Skye Canyon FSED

CITY OF LAS VEGAS		DATE:
INTER-OFFICE MEMORANDUM		July 30, 2019
TO: Land Development Services Department of Building & Safety		FROM: Jennifer Shinn, P.E.  Flood Control, Engr. Associate Department of Public Works
SUBJECT:	Drainage Study for:	COPIES TO:
	Skye Canyon FSED	Nextstep Consulting Engineers
Cross Streets:	Skye Park Drive & Skye Canyon Park Drive	Sunrise Mountainview Hospital
File Number:	F:\Depot\DSMemos\DS5154A.doc	Bart Anderson, P.E., DevCo
Parcel Number:	125-07-210-008	
Zoning Action:	SDR-76807	
FEMA Flood Zone	YES NO X	
Proposed Storm Drain	YES X NO

The Drainage Study for the subject project has been reviewed and:

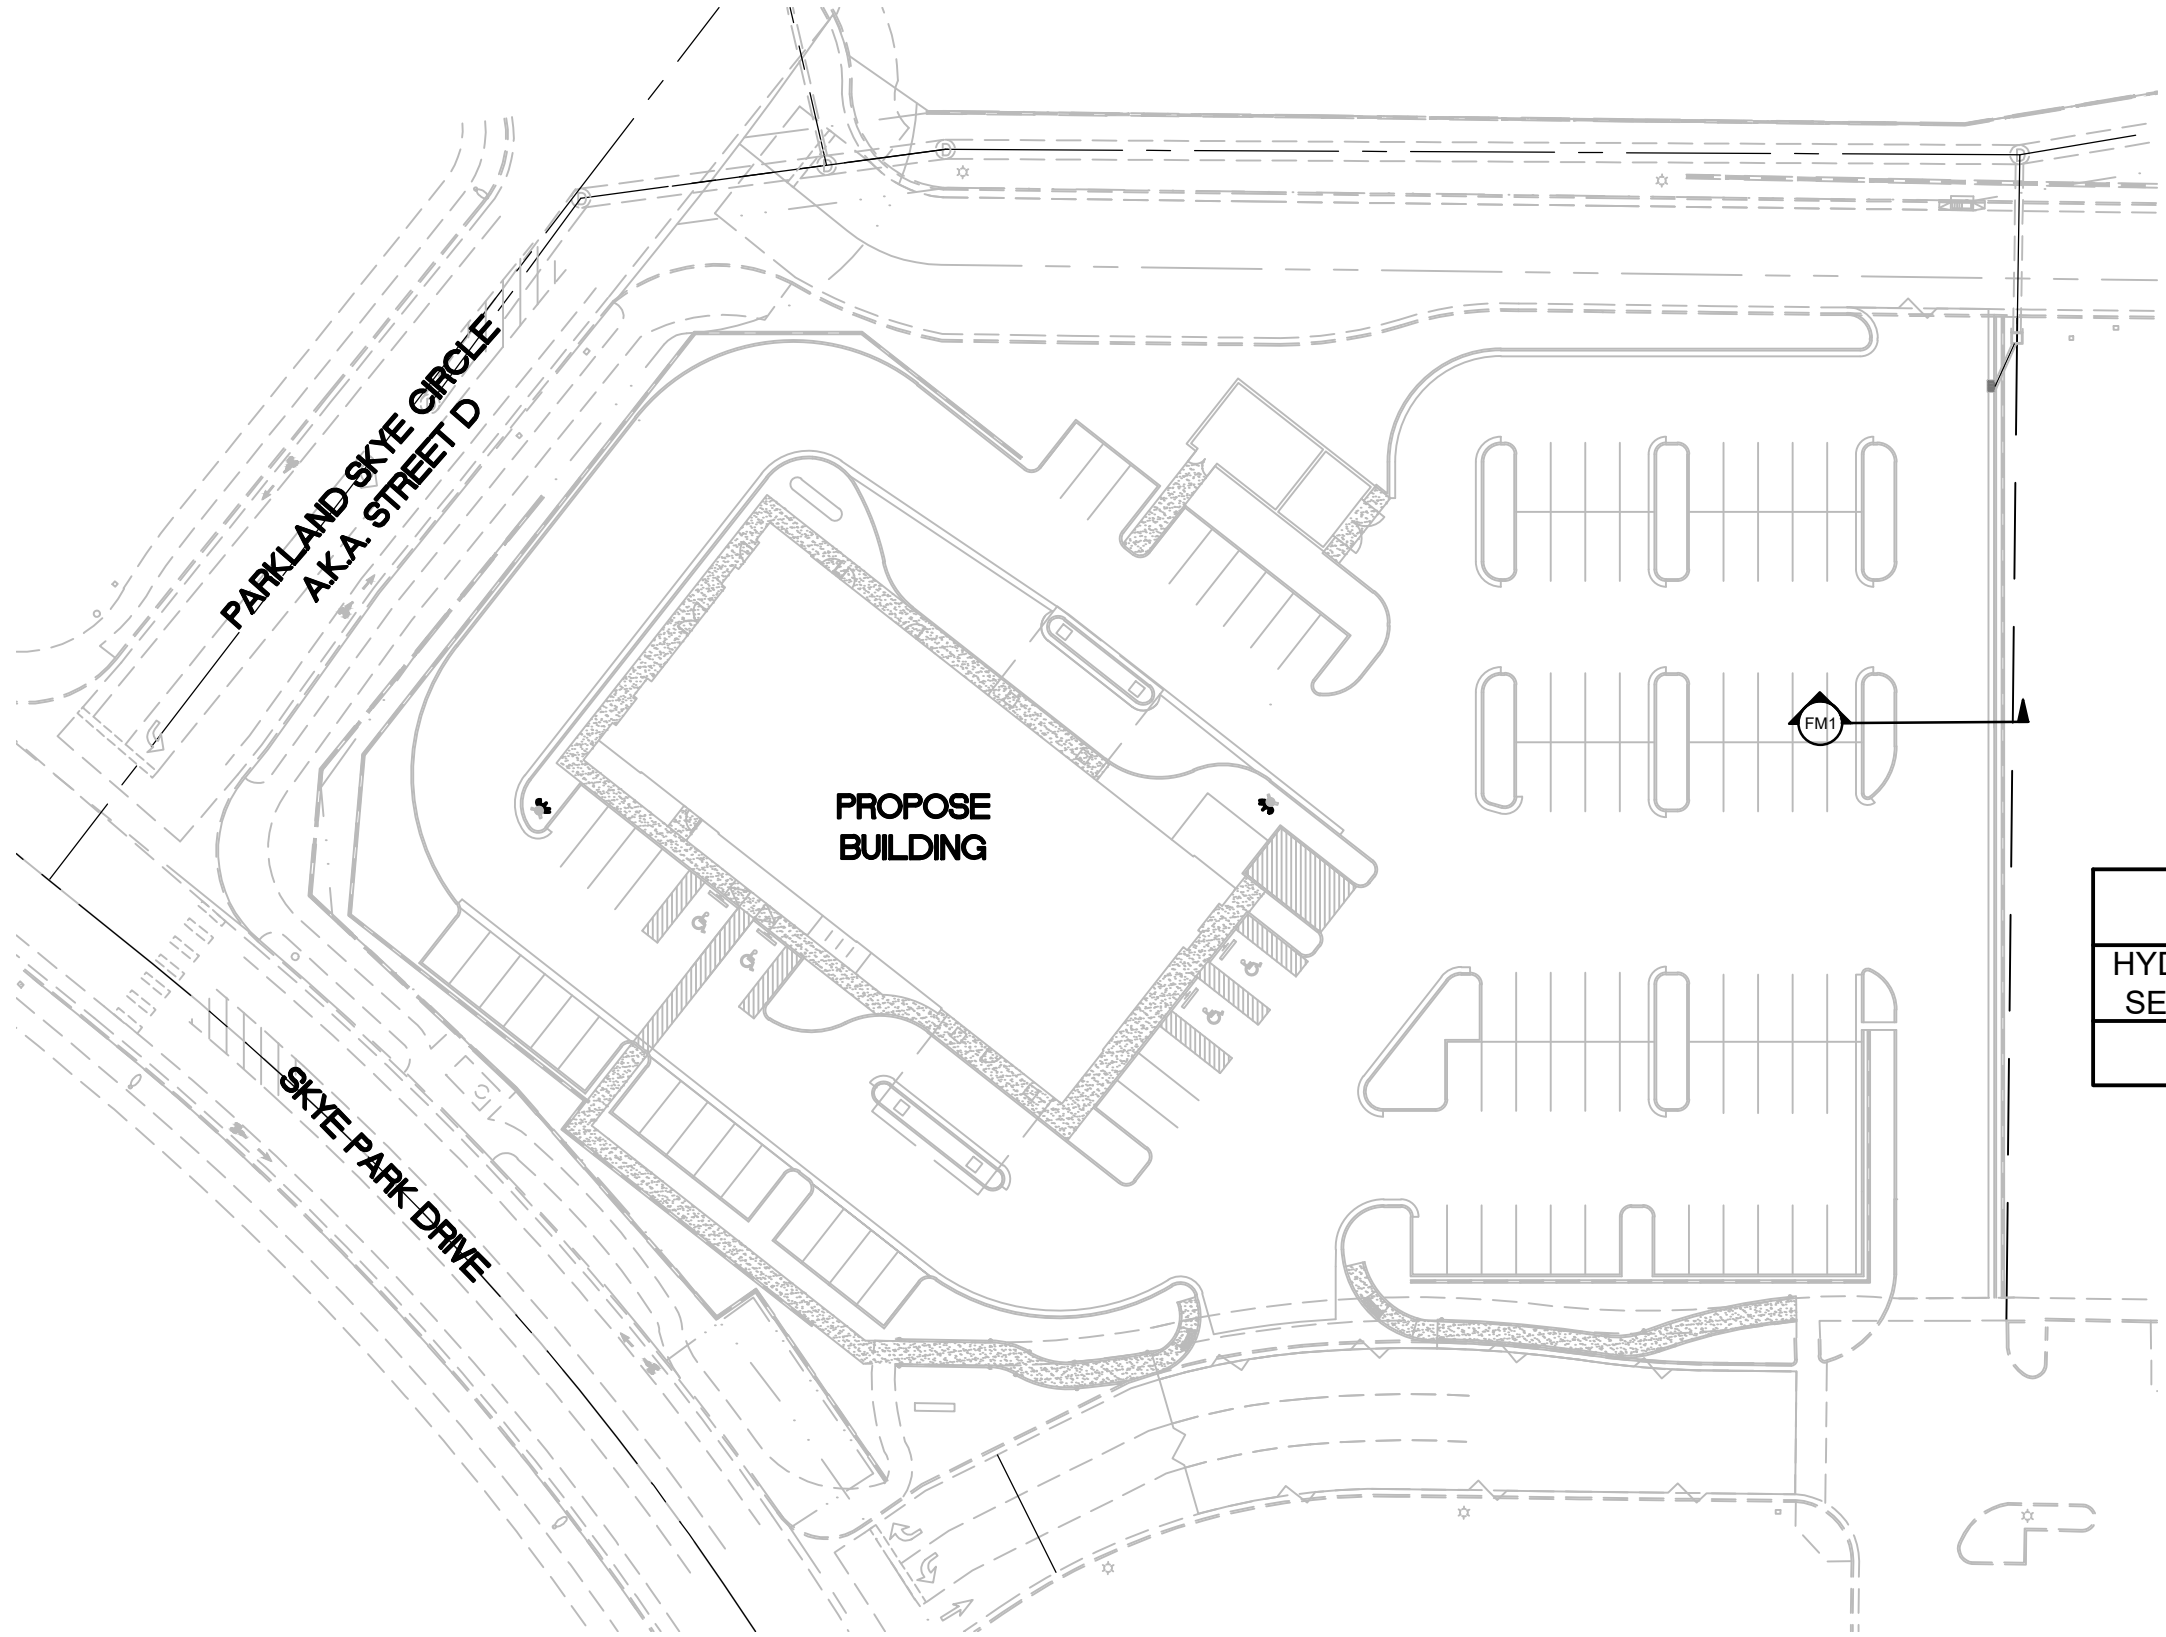
5. The Grading Plan calls out RCP pipe material at a slope of 6.63% while the FlowMaster analysis calls out a 12-inch PVC at 6.3%. Revise the hydraulic analysis to utilize an appropriate roughness coefficient for RCP and the correct slope.

SHEET NUMBER
C4.02

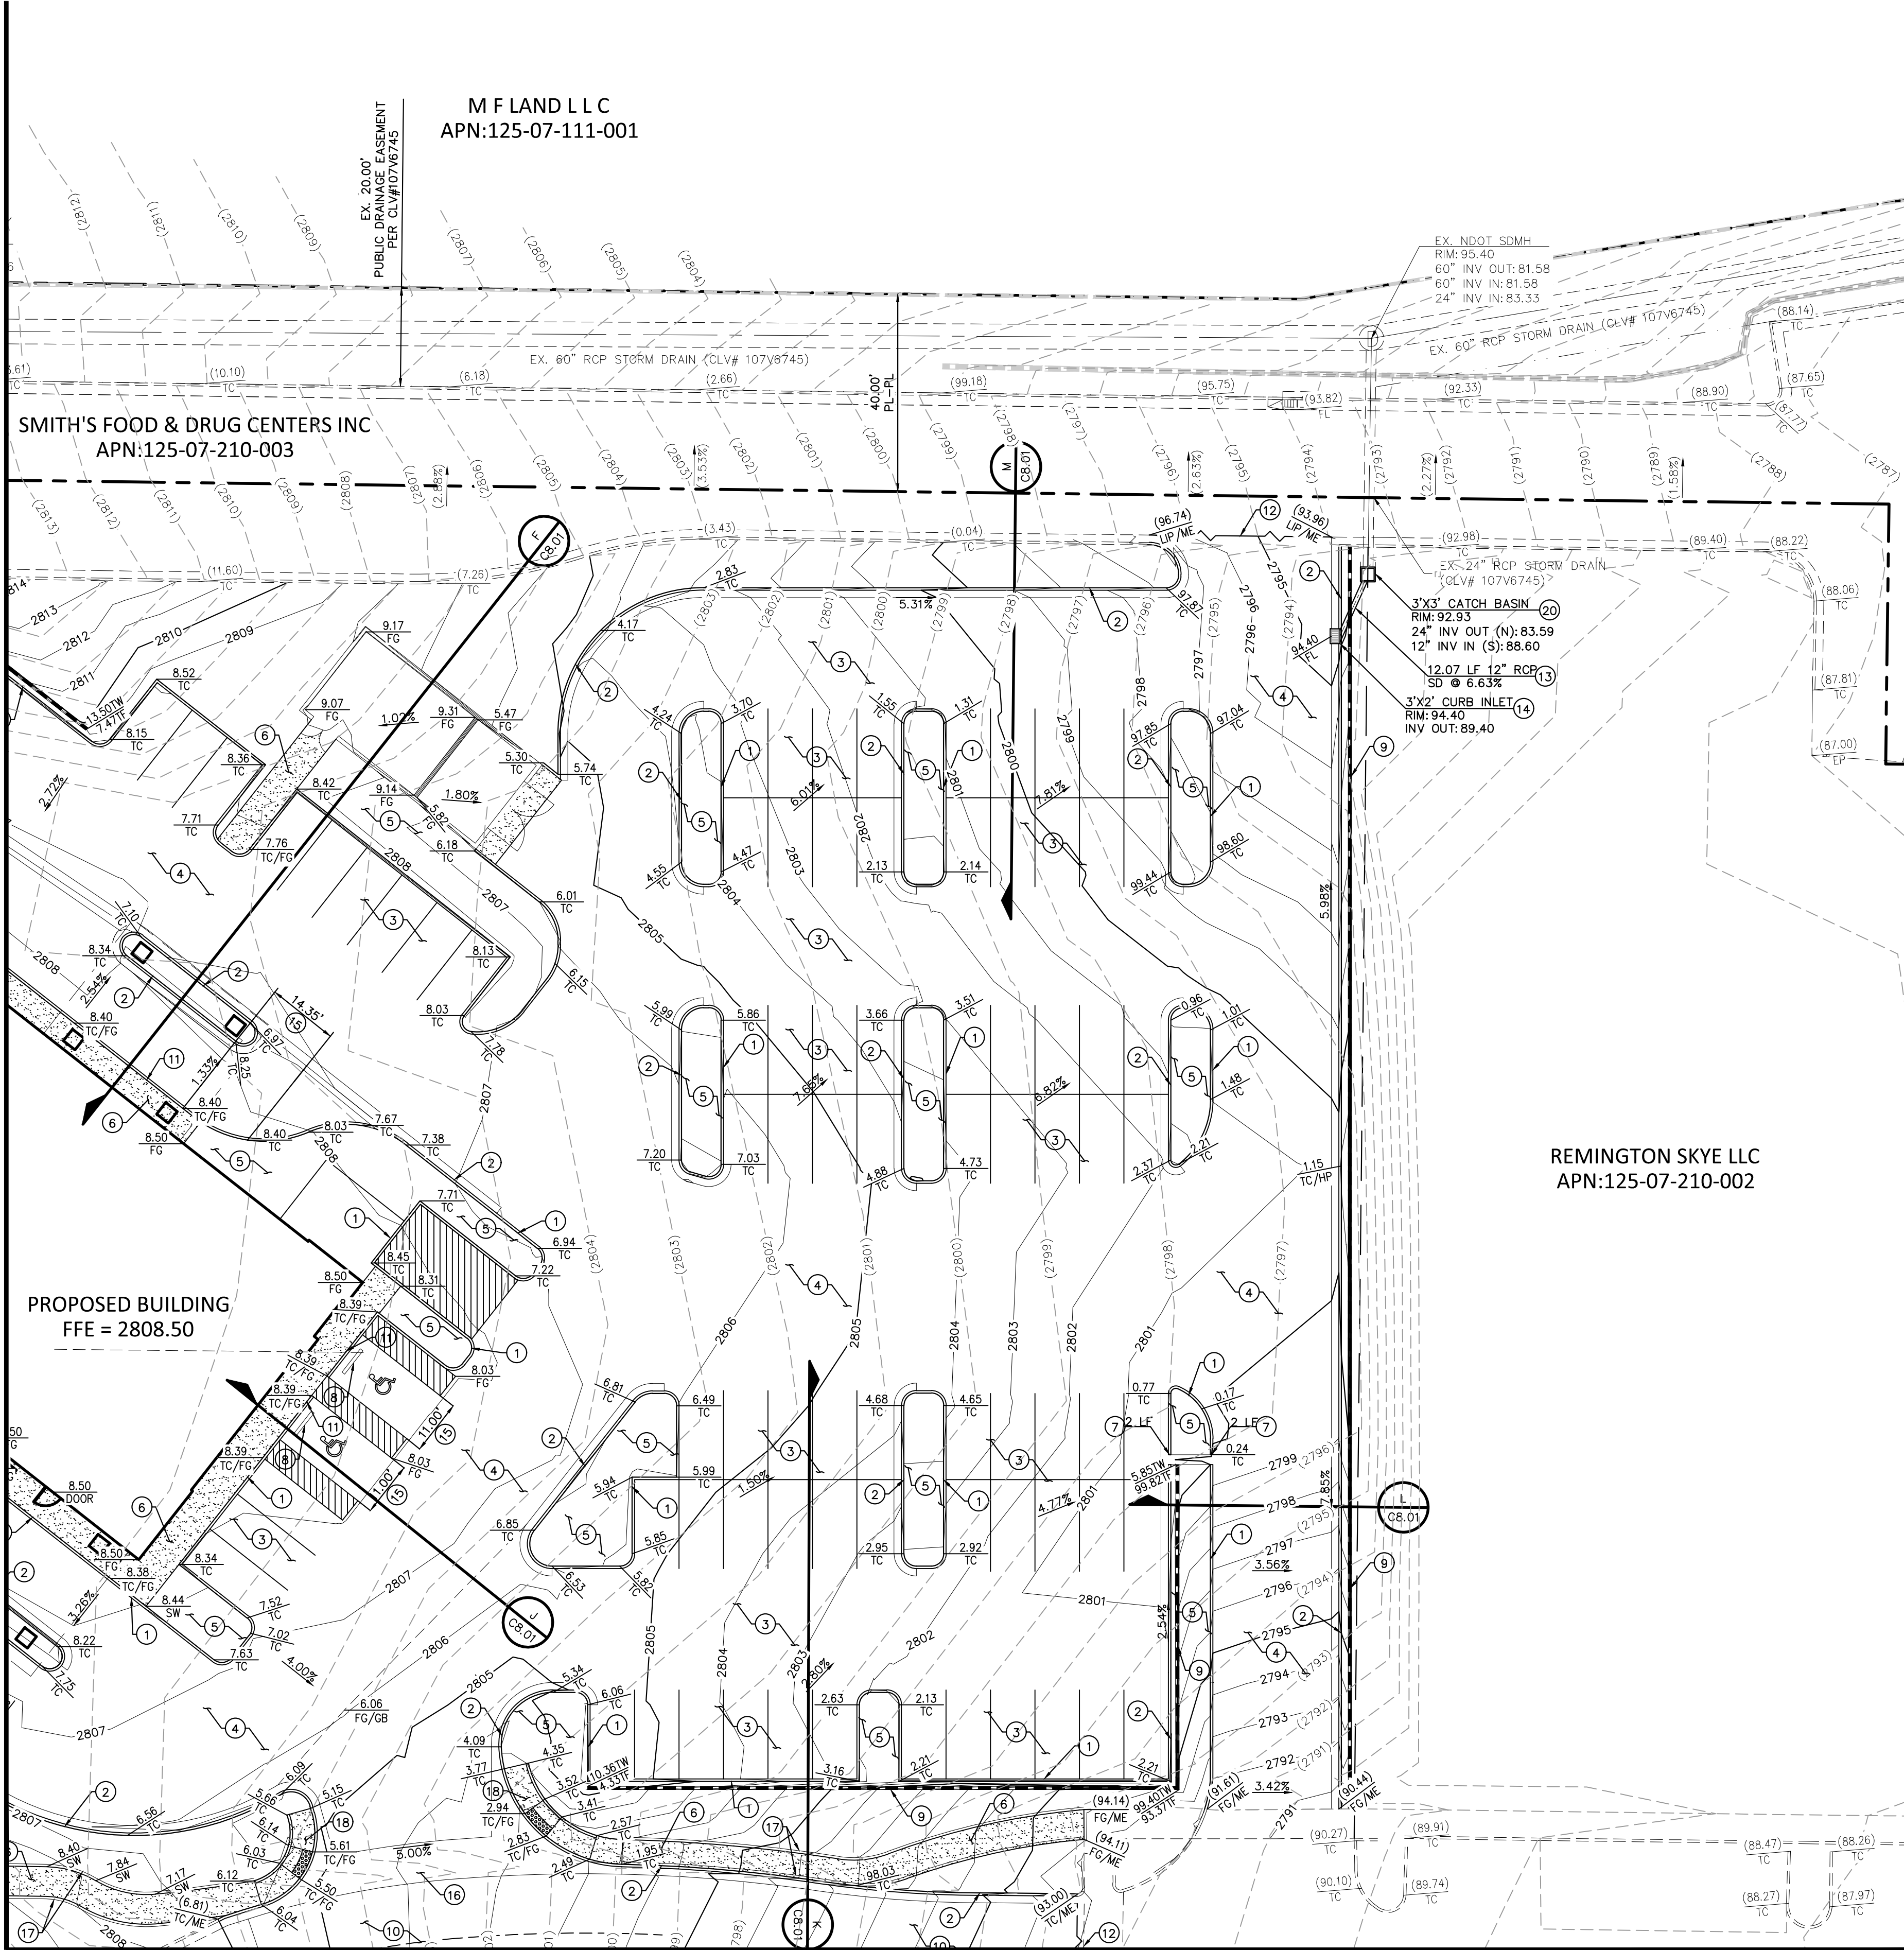
9. Review and revise the walls grades for section K/C8.01 (Sheet C4.02). The TW of 10.36' appears excessively high and the TF of 4.33' is above the adjacent TC of 3.52'.
